SS 732-WST 2022 Low Power Complaint

Applicable Vehicles

Figure 1 Checking for clearance between the throttle pedal and the floor in the full throttle position.

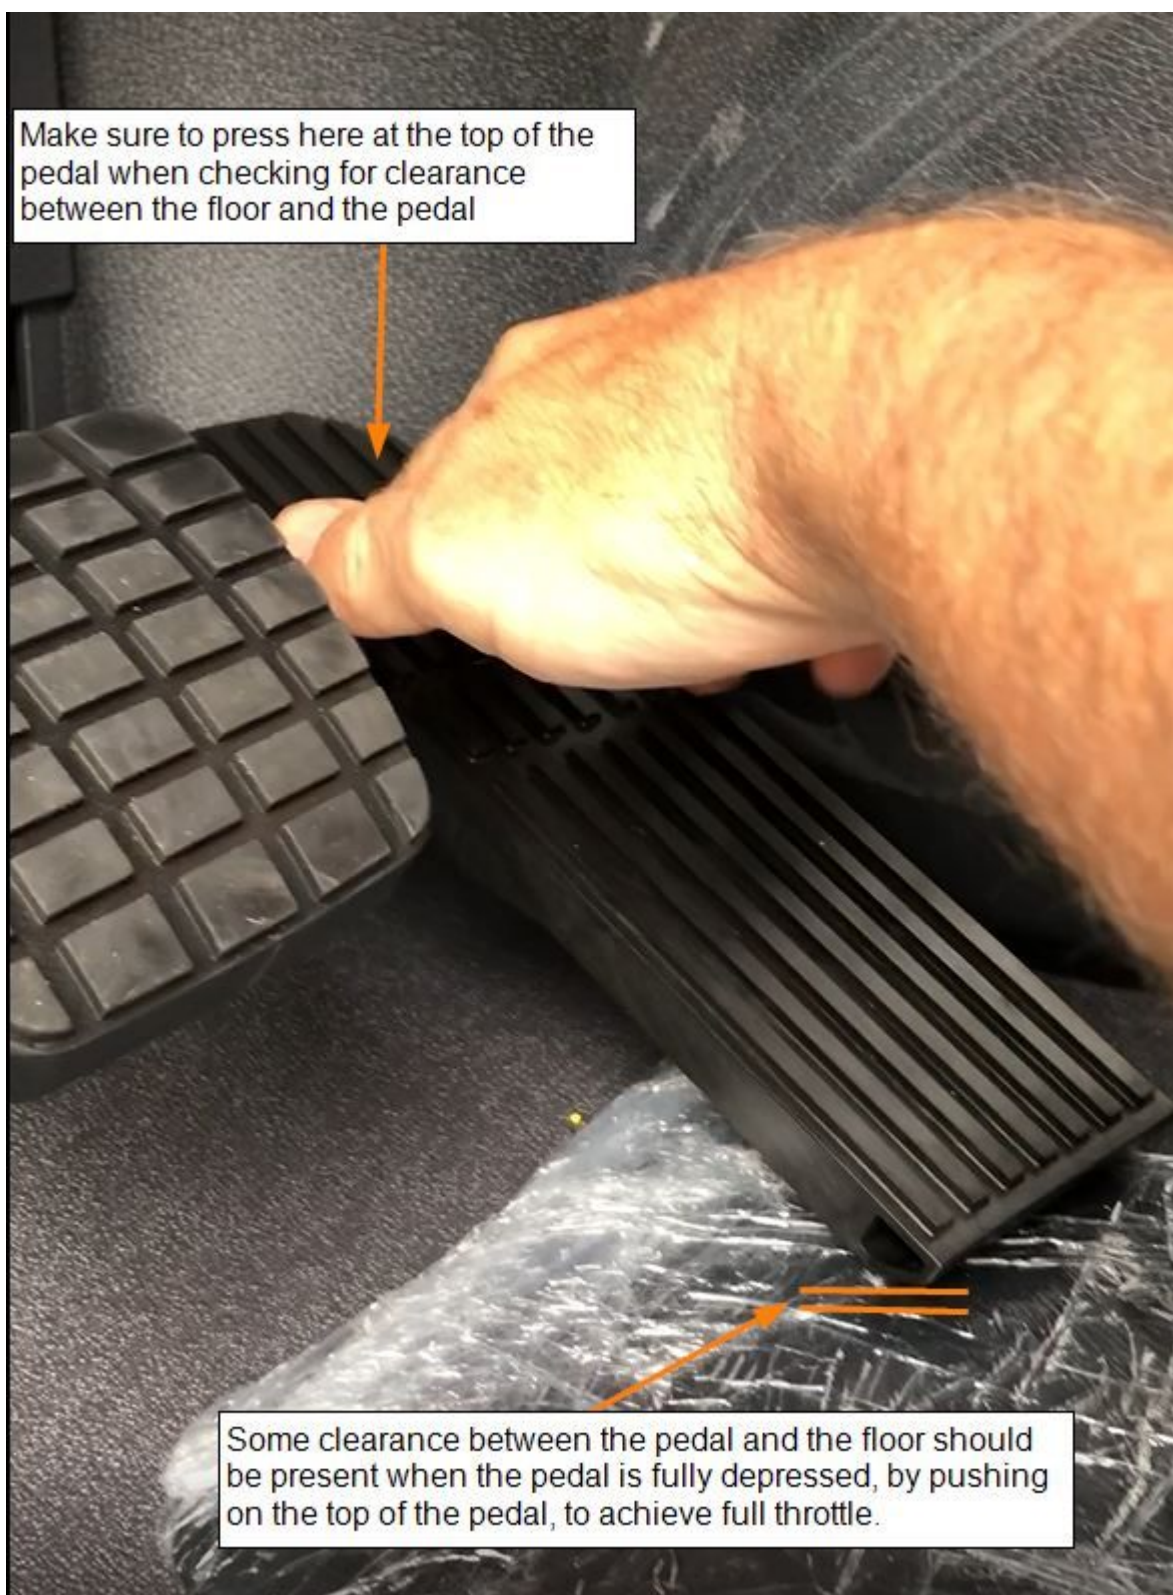
When additional floor heat insulation is ordered, the throttle pedal in some cases (when the throttle is fully depressed) may not reach 100% (full throttle). This can also occur if aftermarket floor mats are added to the vehicle.

The throttle pedal installed in the Western Star vehicle is designed in a way that allows the pedal to pivot on the floor, as the throttle is moved through its range of motion. Although the pedal can pivot on the floor, it typically requires clearance between the floor and the pedal to achieve 100% (full throttle). Referencing Figure 1, when the pedal is placed in the full throttle position by applying pressure to the top of the pedal, there should be some clearance between the floor and the pedal, allowing the pedal to reach 100% movement. If a customer complains of low engine power, make sure to check for clearance between the throttle pedal and the floor as displayed in figure 1. If there is still a concern with the pedal movement, monitor the throttle pedal position using the

appropriate diagnostic tool (DiagnosticLink for Detroit engines and Cummins Insite for Cummins engines). While fully depressing the throttle pedal, monitor the pedal position within the diagnostic tool, the pedal position should read 100%. If an aftermarket floor mat has been added, it is best to start by removing the floor mat and testing the throttle again, fully depressing the pedal while monitoring the pedal position within the tool. If 100% throttle is achieved then no further action is required and the aftermarket floor mat should not be reinstalled. If there is no aftermarket floor mat, fully depressing the throttle pedal, the throttle pedal should display 100% when monitoring it with the diagnostic tool. If the throttle pedal does not read 100% and there is no clearance between the throttle pedal and the floor, it is recommended that the extra heat insulation be removed from the drivers station as noted in Figure 2 for left hand drive vehicles and figure 3 for right hand drive vehicles. A picture of the foil faced heat insulation that will be removed is shown in Figure 4. Upon removal of the foil faced insulation, the throttle pedal should be checked one final time for clearance between the pedal and the floor, while while monitoring the diagnostic tool when the pedal in in the full throttle position validating 100% pedal position is achieved.

Figure 2 For left hand drive vehicles, the added insulation marked in red box should be removed to provide additional floor clearance for the throttle pedal when needed.

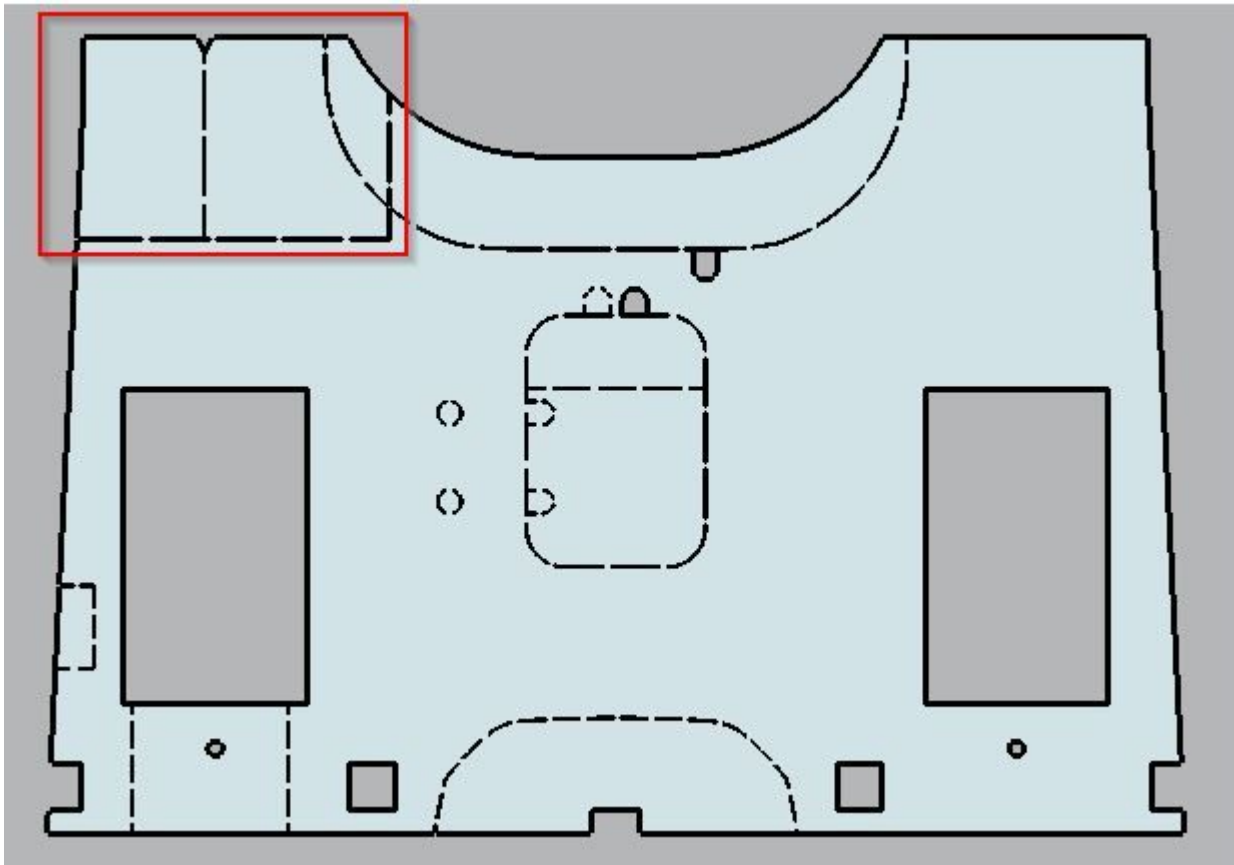
Note: Vehicles receiving this added heat insulation built after mid year 2023 will be having the added heat insulation removed in the areas documented in figures 2 and 3.
